WSRC-RP-2003-00362
Revision 2

ESTIMATED DURATION OF THE SUBSURFACE REDUCING ENVIRONMENT PRODUCED BY THE Z-AREA SALTSTONE DISPOSAL FACILITY (U)

11.0 APPENDIX C: DESIGN CHECK INSTRUCTIONS AND REVIEW

Figure 1. Conceptual Model (Vault is assumed to be cracked in half, i.e., the vault is twice the x-axis. Diagram represents one of the two equally sized vault fragments. Crack is located on the left edge above.)

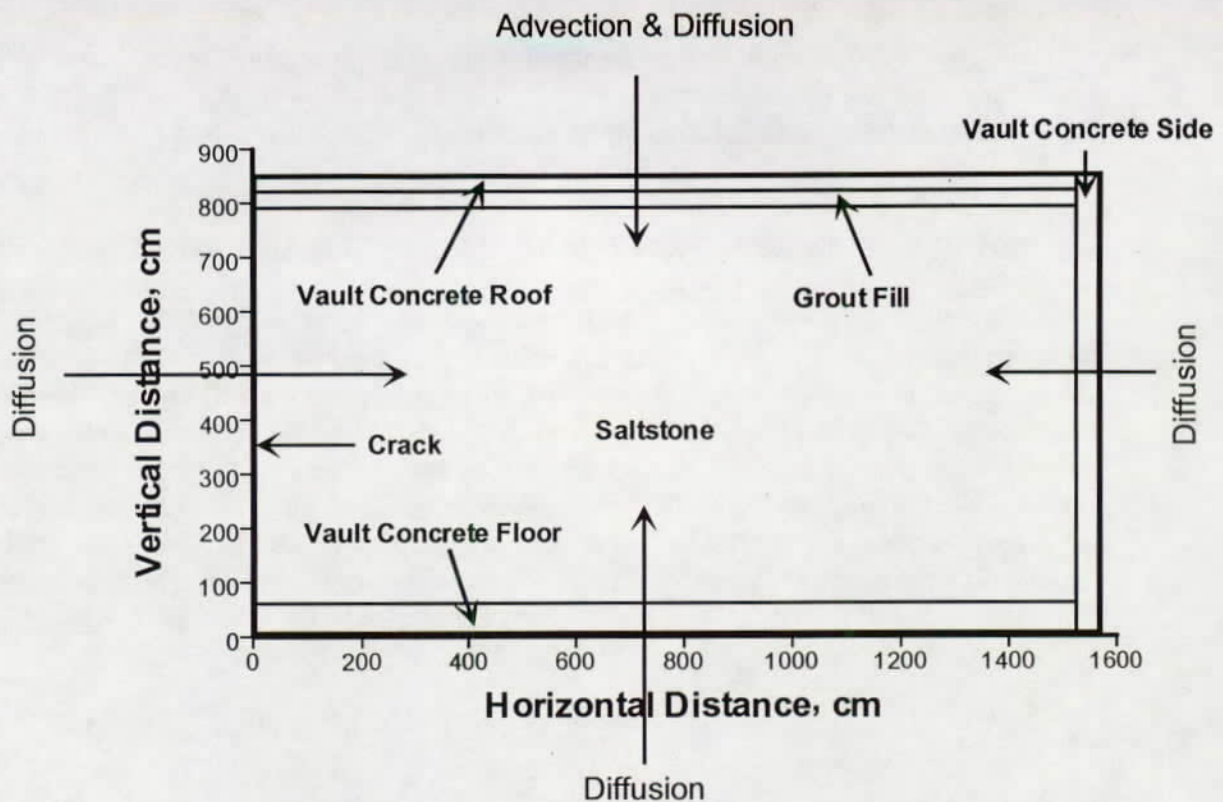
Conceptual Model section I would say more explicitly that the left side of the conceptual model assumes a crack that extends fully from the top of the Saltstone monolith to the bottom and which allows movement of water along the full length.

3. Figure 1: in diagram make location of crack evident.
4. Error bars on Figure 3 are inconsistent.
5. Table 4. a) rather than *Calculations for Estimating* Oxidation capacity of Salt Solution...I would suggest Estimation of Oxidation Capacity of Salt Solution based on Oxidizing Constituents (or ingredients). Should be "Used in equation 2" not equation 3. Footnote b) should read <1E-04 molesL-1).

Figure 4. Simulation Result at 250,000 Years (Units in $\text{meq } e^-/g_{\text{solid}}$). Red Indicates no Oxidation of Saltstone Occurred and Blue Indicates that Full Oxidation of the Saltstone Occurred.

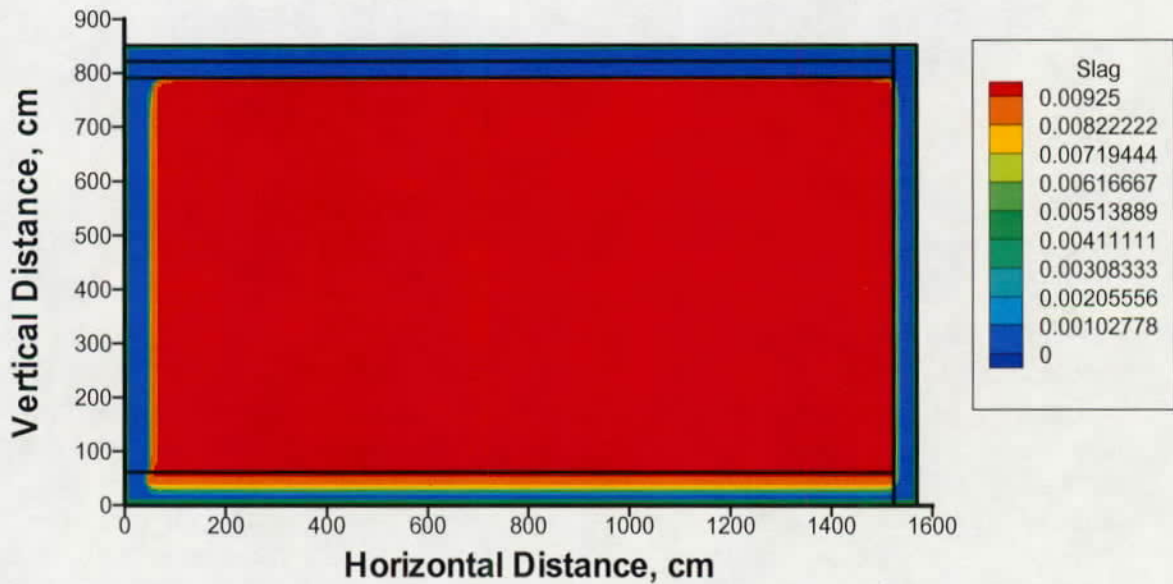
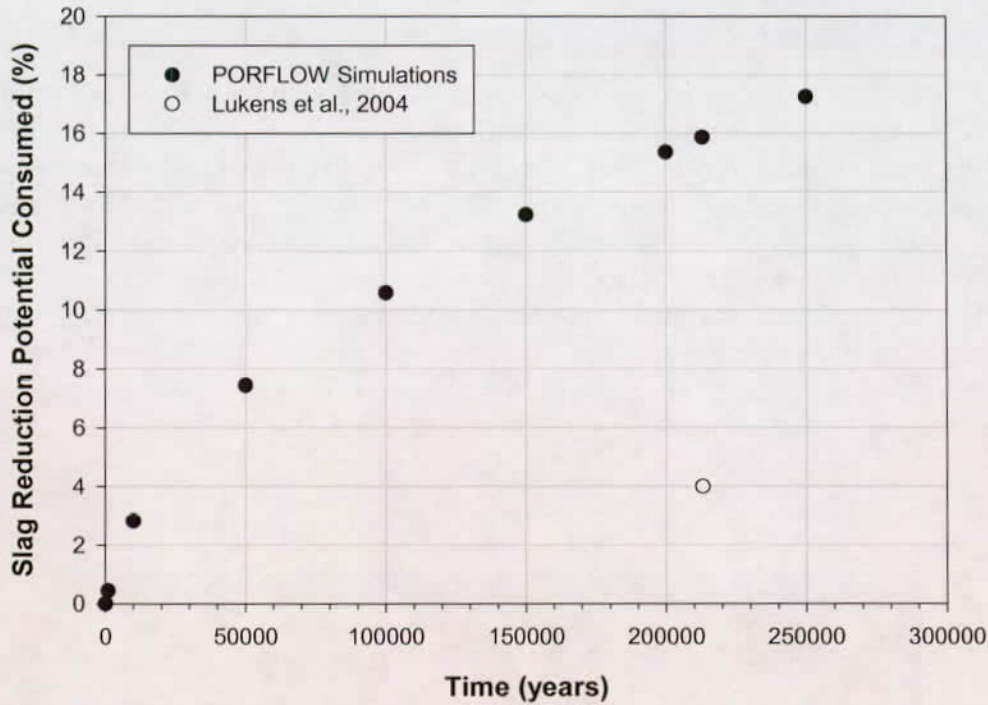
- 3b. Figures 4 and 5 were spot checked using Porflow output for 50,000, 150,000 and 250,000 years. The same values were obtained for the percentage of species C2 (slag) consumed at these times as is shown in Figure 4. Using output for the same years to evaluate the depth of slag oxidation on the left face at J=33, the same values for depth of penetration were obtained as is shown in Figure 5. The graphs accurately reflect the results obtained from model simulation.
